**VALIDATION OF THE
MOKPO LANDFILL GAS RECOVERY PROJECT
FOR ELECTRICITY GENERATION
IN REPUBLIC OF KOREA**

REPORT No. 08-001
REVISION No. 08

ENVIRONMENTAL MANAGEMENT CORPORATION

Figure 2. Linear regression analysis using a unit cost of electricity purchase

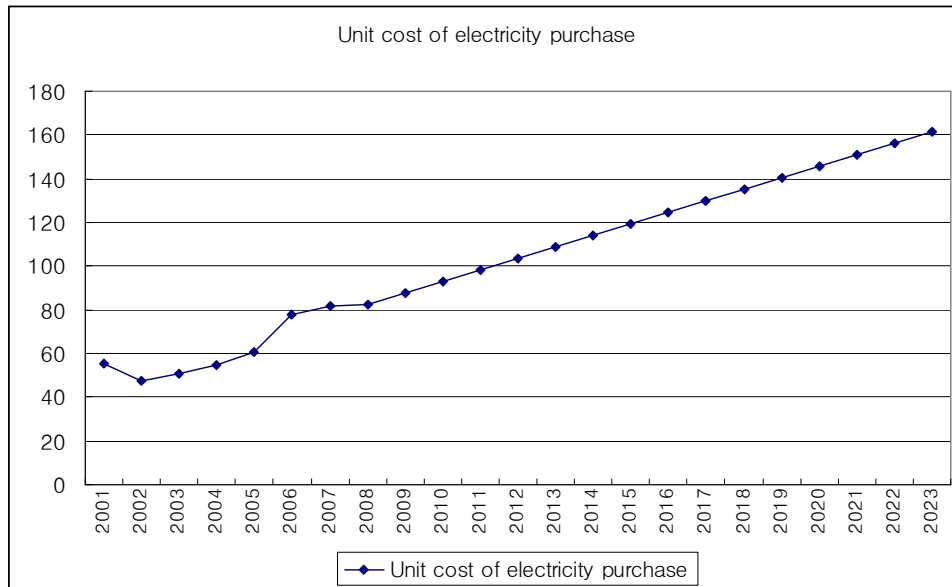
- EMC conclude that it is reasonable for setting a same unit price of electricity sales through whole project lifetime because of high uncertainty of future assumption. EMC carried out linear regression analysis using a publically opened data from 2001 to 2007⁹⁾ to estimate the possibility of increasing. Average unit price of electricity sales is 122 won/Kwh during project lifetime, and IRR is -1.37% which is much smaller figure than benchmark ratio (5.24%). Unit price of electricity sales should be over 140.3won/Kwh to be economically attractive and IRR will cross the benchmark ratio.
